## DRAFT TECHNICAL MEMORANDUM

To: Daryn Hardwick, Groundwater Modeling Manager, Texas Water Development Board  
From: Stephanie J. Moore, PG, INTERA Incorporated  
Date: April 30, 2025  
Re: Final Stakeholder Advisory Forum for Development of the Cross Timbers Aquifer Numerical Model

Stakeholder Advisory Forum (SAF #2):  
**Cross Timbers**  
**Groundwater Availability Model**

# Recharge

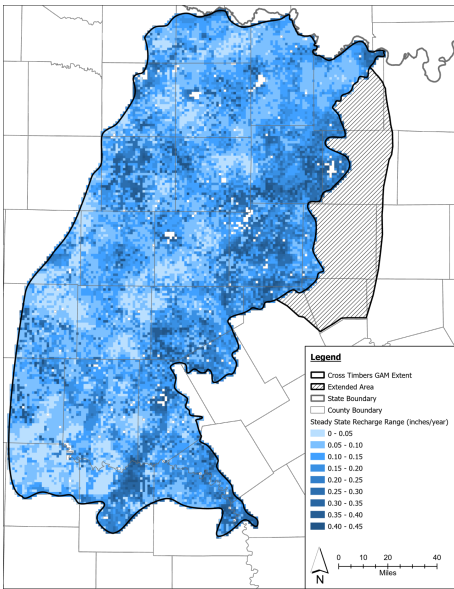
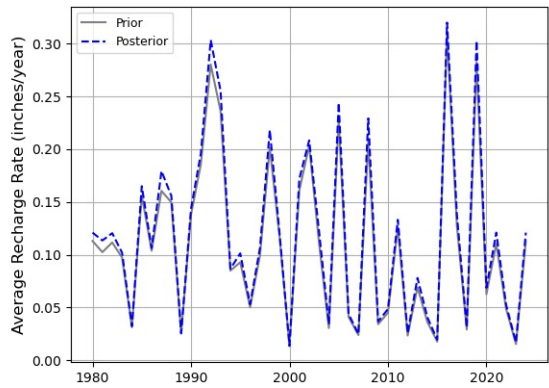
3. **Neil Blandford had comment: The way we had done the conceptual model, is that the recharge can exceed precipitation at a given location if it's focused recharge, where runoff is focused to a particular location. It can and often does exceed the precipitation at that location.**

Response: Yes, we understand that recharge has very high level of uncertainty because of lack of data. There is a large amount of variability in diffuse and focused recharge and relatively little data, particularly for the Cross Timbers study area. Better data for recharge is one of the areas that we specifically call out as having room for future improvement.

A good amount of focused recharge spots ended up aligning with our rivers and drain cells. The river package specifically would still allow focused recharge to happen (where the river is losing water) in quantities greater than precipitation.

## Water Level Targets

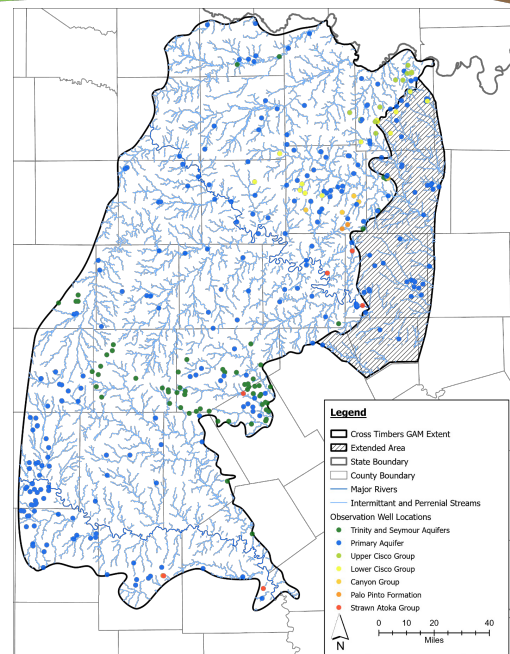
2. **Michaela Pedrazas asked: Regarding the water level targets, 1) When averaging water levels to get annual values, did you filter water levels to just winter water levels to avoid including the effect of pumping? 2) What are you hanging the water levels from? (10m DEM?)**

Response: For averaging annual water levels, we used a rolling average technique with the goal of smoothing out any impacts from pumping. We have an appendix in the report with all the hydrographs of raw data. Most of our water levels are actually collected during winter months so we had minimized any bias from pumping.

Yes, water levels are hung from the 10-m DEM. Often, elevation data provided by drillers is inaccurate (often ready by handheld GPS units), so we re-sampled our well locations to the DEM, which has a 30-foot by 30-foot resolution.
